RANCHO SANTIAGO COMMUNITY COLLEGE DISTRICT

ADDENDUM NO. 02

Bid #1491 BUILDING G HVAC Replacement Project
at
SANTA ANA COLLEGE

Project ID #2957.1, DSA #04-123961

SHEET **E3.00**

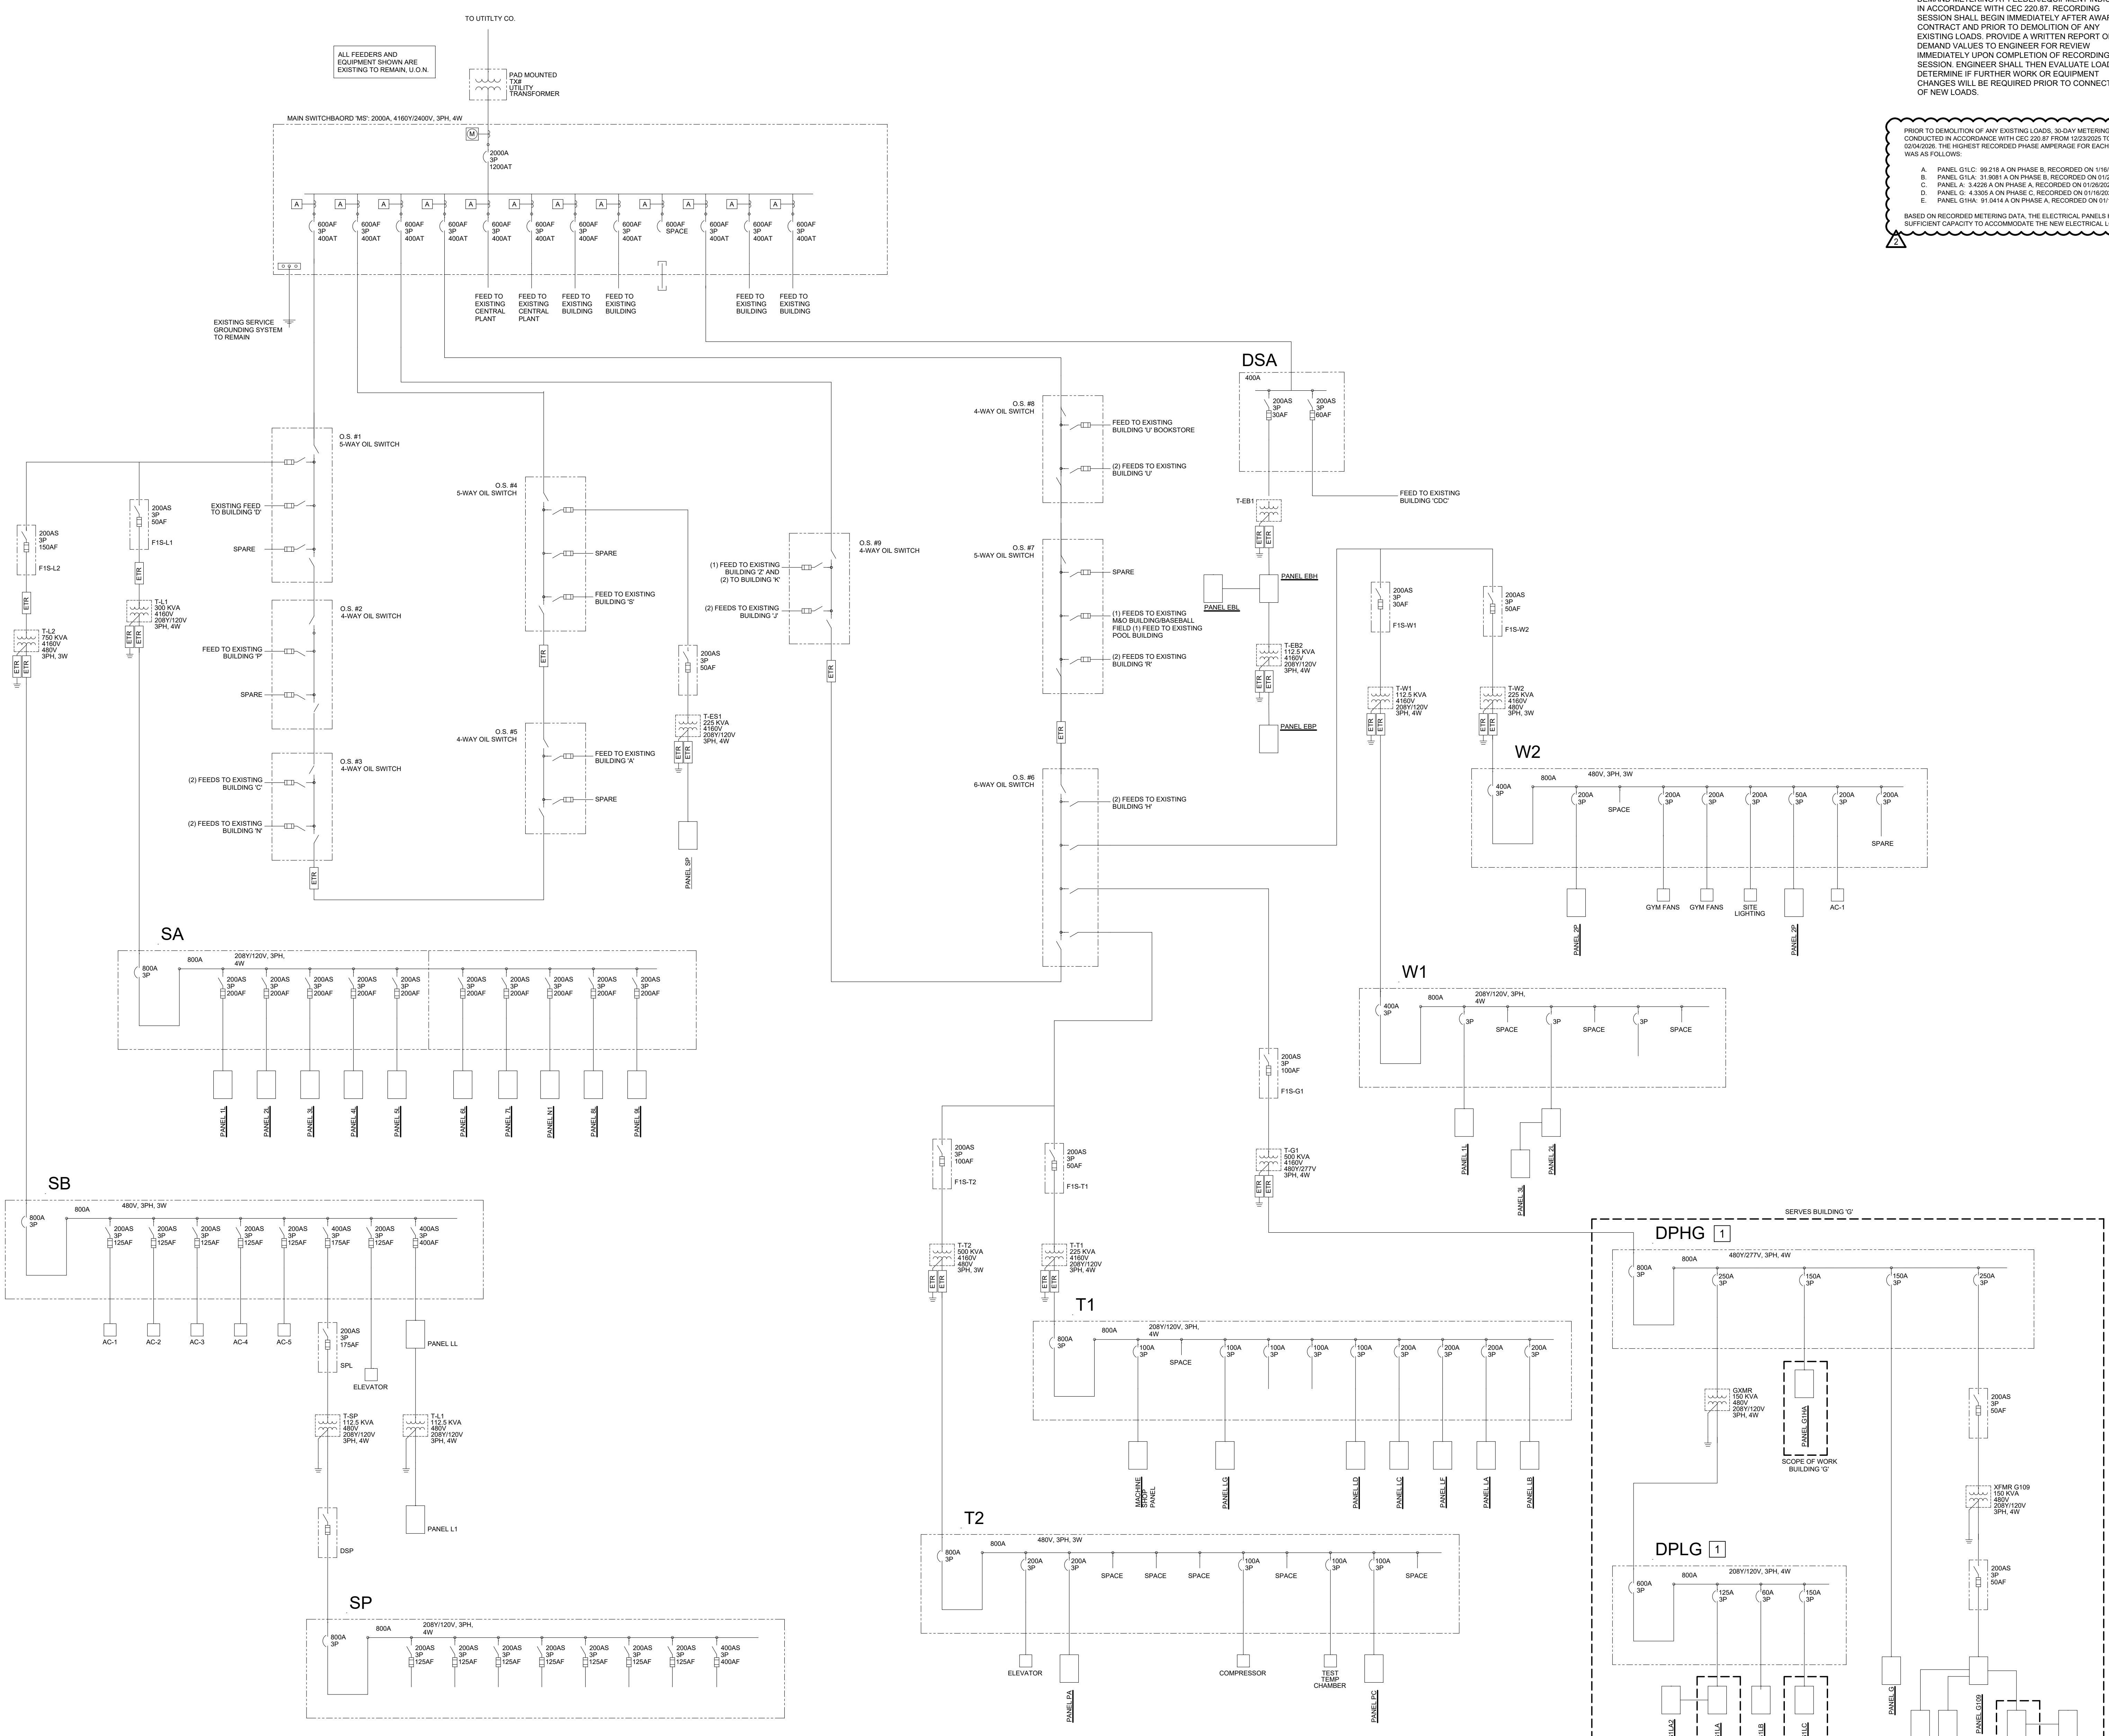
- b. Inserted: "G1LA-40" at EF G-1
3. SHEET E3.00, ELECTRICAL ONE-LINE DIAGRAM:
 - a. Inserted: "PRIOR TO DEMOLITION OF ANY EXSTING LOADS, 30-DAY METERING WAS CONDUCTED IN ACCORDANCE WITH CEC 220.87 FROM 12/23/2025 TO 02/04/2026. THE HIGHEST RECORDED PLASE AMPERAGE FOR EACH PANEL WAS AS FOLLOWS:

- A. PANEL G1LC: 99.218 a ON PHASE B, RECORDED ON 1/16/2026
 - B. PANEL G1LA: 31.9081 A ON PHASE B, RECORDED ON 01/29/2026
 - C. PANEL A: 3.4226 A ON PHASE A, REOCRDED ON 01/26/2026

- D. PANEL G: 4.3305 A ON PHASE C, RECORDED ON 01/16/2026
 - E. PANEL G1HA: 91.0414 A ON PHASE A, RECORDED ON 01/16/2026BASED ON RECORDED MEATERING DATA, THE ELECTRICAL PANELS HAVE SUFFICIENT CAPACITY TO ACCOMDOATE THE NEW ELECTRACL LOADS." below ELECTRICAL PLAN NOTE 1

PRIOR TO DEMOLITION OF ANY EXISTING LOADS, 30-DAY METERING WAS CONDUCTED IN ACCORDANCE WITH CEC 220.87 FROM 12/20/2020 TO 03/20/2021. THE HIGHEST RECORDED PHASE AMPERAGE FOR EACH PANEL WAS AS FOLLOWS:

- A. PANEL G1.C. 99.218 A ON PHASE B, RECORDED ON 1/16/2020
- B. PANEL G1.A. 31.981 A ON PHASE B, RECORDED ON 01/29/2020
- C. PANEL A. 3.428 A ON PHASE A, RECORDED ON 01/29/2020
- D. PANEL G. 4.305 A ON PHASE C, RECORDED ON 01/16/2020
- E. PANEL G1.A. 31.644 A ON PHASE A, RECORDED ON 01/16/2020

BASED ON RECORDED METERING DATA, THE ELECTRICAL PANELS HAVE SUFFICIENT CAPACITY TO ACCOMMODATE THE NEW ELECTRICAL LOADS.

RFI response No. 04

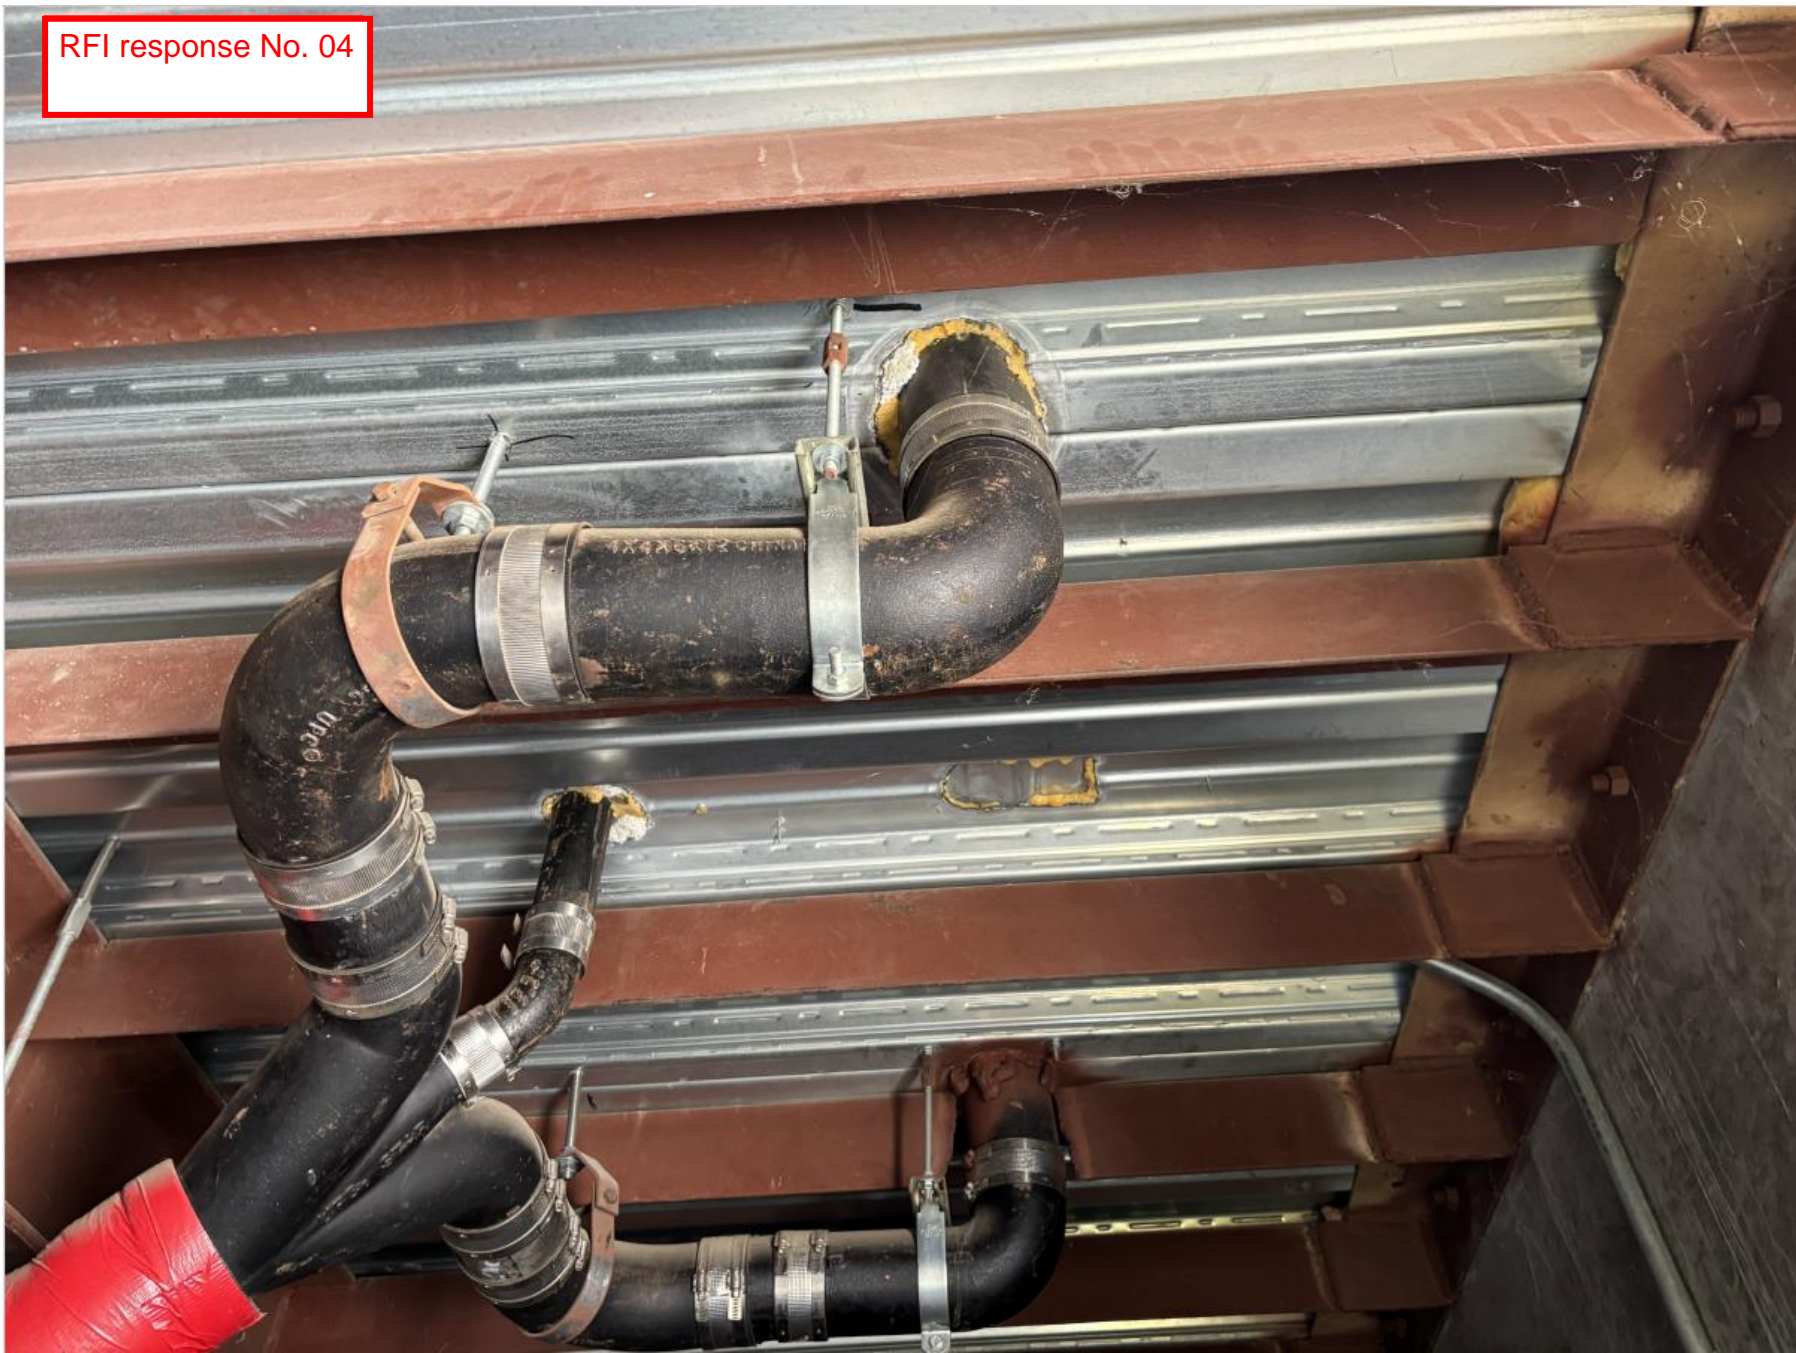
PROJECT NAME:	Building G HVAC Replacement Project at Santa Ana College (SAC)		
PROJECT NUMBER:	2957.1	BID NUMBER:	1491
EMAIL TO: facilitiesbid@rsccd.edu			
DATE:	3-24-26		
FROM:	Allison Mechanical, INC	EMAIL:	Office@Allison1.net
SPEC SECTION:		DRAWING NUMBER:	
REQUESTED CLARIFICATION:			
What is the ceiling type in the Mechanical room G135 where the new copper will be ran through			
RESPONSE TO CLARIFICATION:			
Robinson metal decking, Refer to image below in Response to RFI No. 04 below.			
RSCCD 04/06/26
